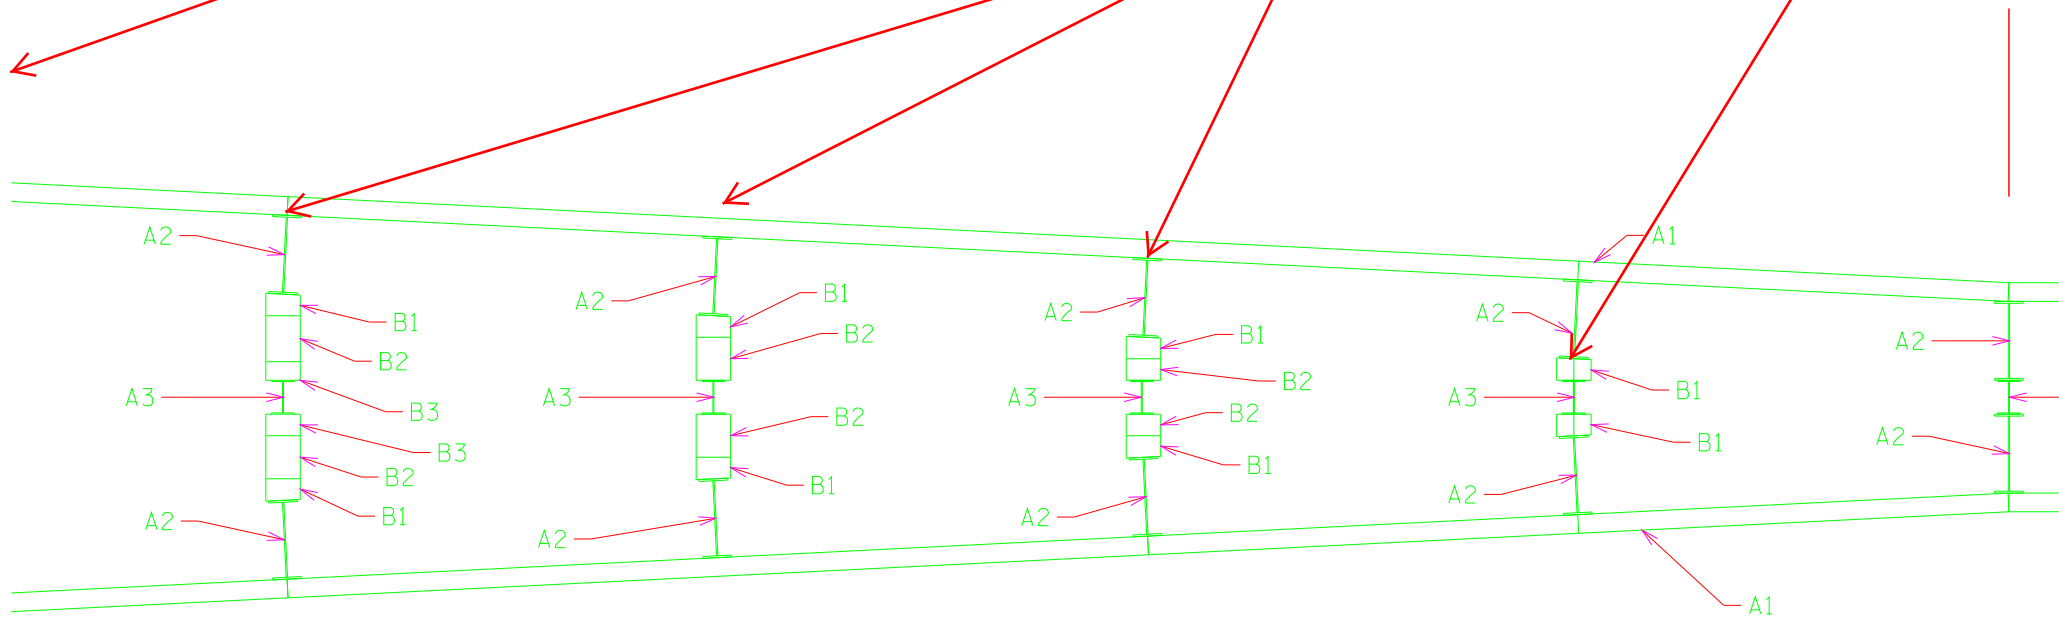
Next set of post  
has just over 2'  
between back of  
posts

But wouldn't two  
post be too close  
together here?

Designs I have  
seen only have one  
post with spacer  
blocks.
